Hobpton High School Replacement CM Clarification #03

Date: May 11, 2026

Project: **Sampson County Schools – Hobpton High School Replacement**

Details 7,8 & 9/A-550 reference structural drawings for reinforcing requirements; this information could not be found. Please provide

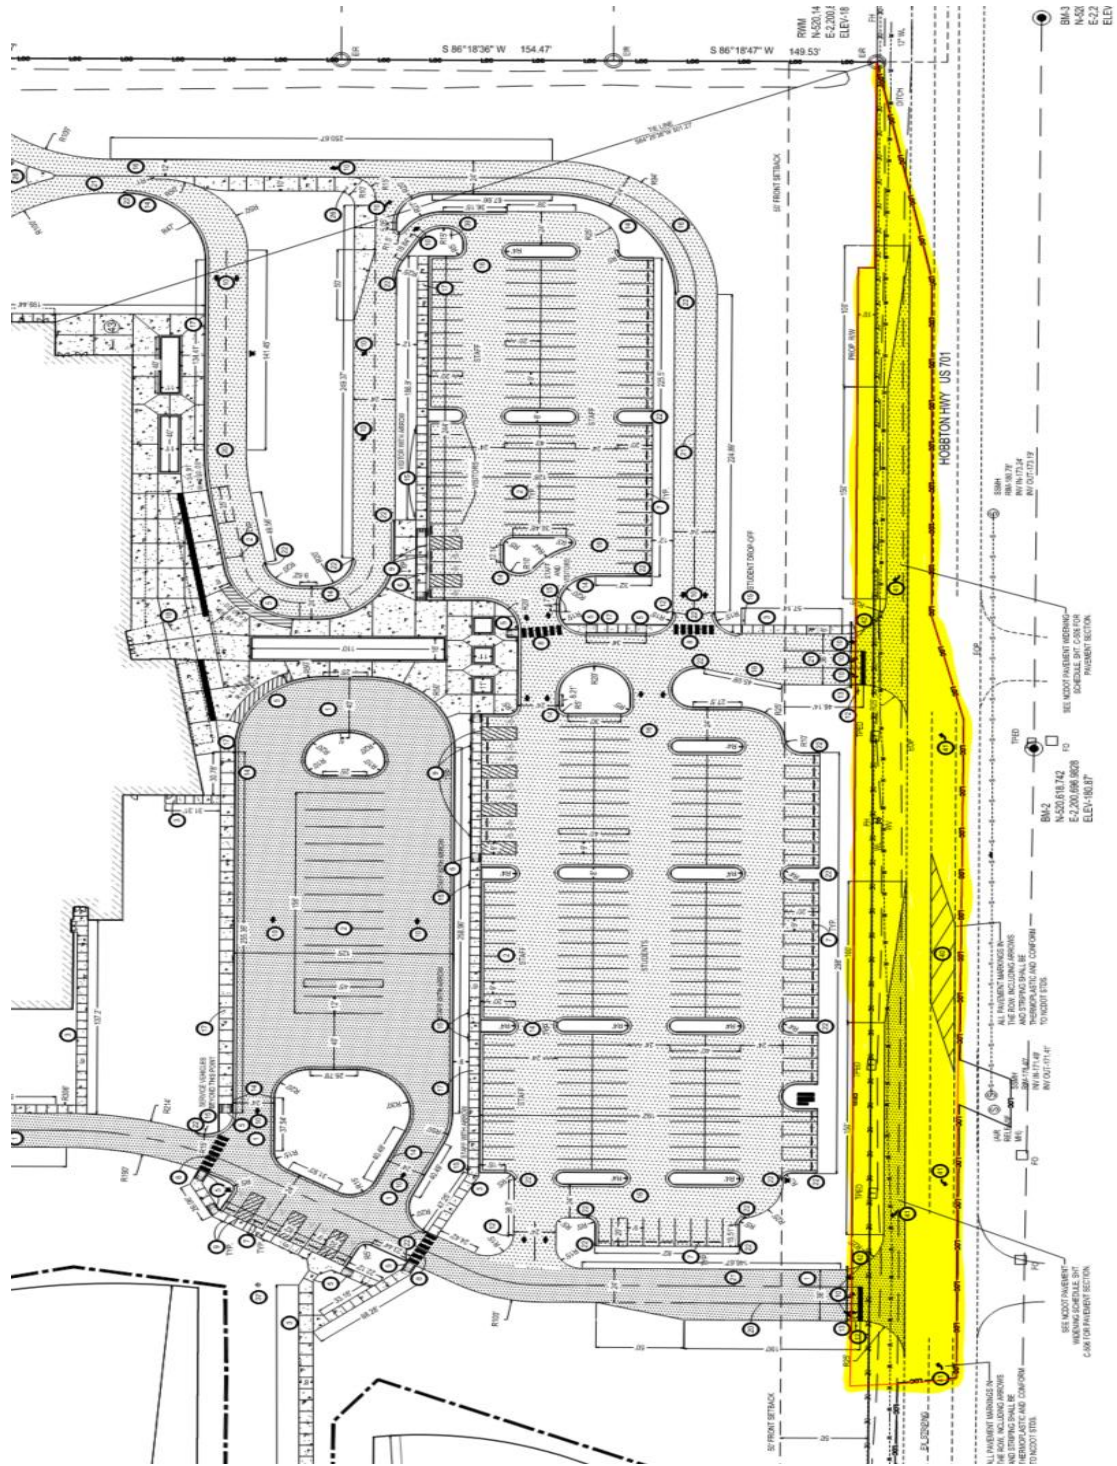
Scope Inquiry: **Monumental Site Sign and Site Wall**
Details 7,8&9/A-550 reference structural drawings for reinforcing requirements; this information could not be found. Please provide

CM Response: Please see attached detail for reference

CM Response: Refer to detail below
